Montecito Fire Protection District

Fire Station 92 – Gates & Carport

ITB# 2024-002

Responses to Bidder Questions:

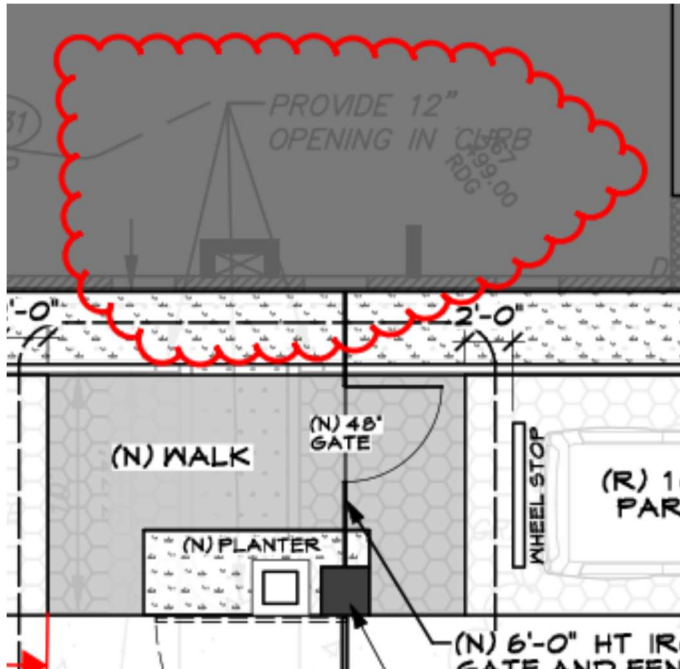
- b) Plans call for new precast pavers for uncovered parking space to the West of the new Carport, and new pavers to be infilled throughout the site. Please clarify the type/ specification & color of pavers to be supplied and installed?

Response: *Existing pavers to be reused, first at the gate parking spots (complete coverage) and second at the carport. There are not enough existing pavers to complete the area shown at the carport so existing pavers will be installed from the inside out, centered in a rectangular pattern matching the carport layout. New pavers will create a uniform border around the existing pavers.*

Manufacturer: Belgard paver

Model: Holland stone -Heritage collection

Color : Rio color (Light gray)

Thickness: 80 mm thickness (60 mm ok if 80 mm not available)

Size 4" x 8" x 2 3/8"

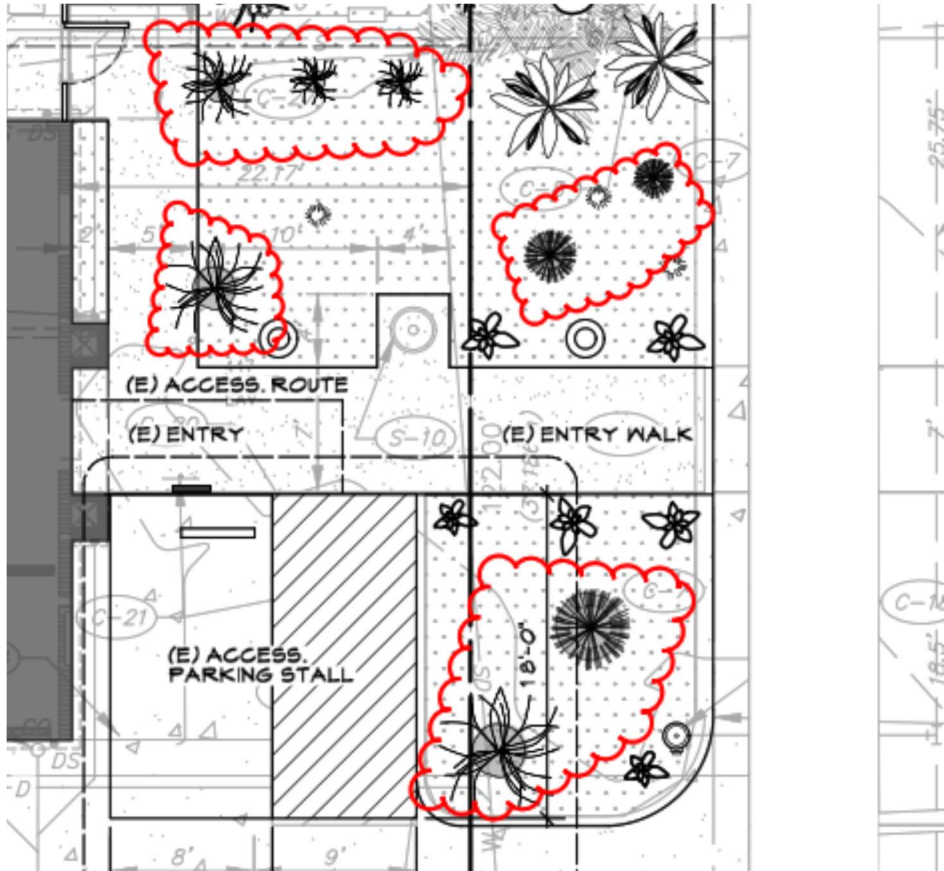
- c) Hidden in the shaded area in the building states "Provide 12" Opening in Curb". Please clarify what this is and provide details for the opening (see image below).

Response: *This is not a part of the scope of work. This is an archive from the existing original plans.*

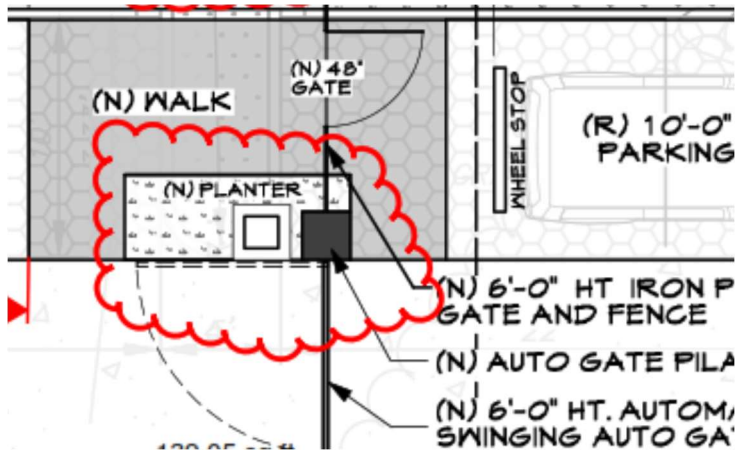
- f) New planter is shown to be installed at new walk area located adjacent to new man gate. Please clarify what planting materials are to be installed at this location (see image below).

Response: *Sleeving to be provided to this area but otherwise, landscaping is not part of this bid.*
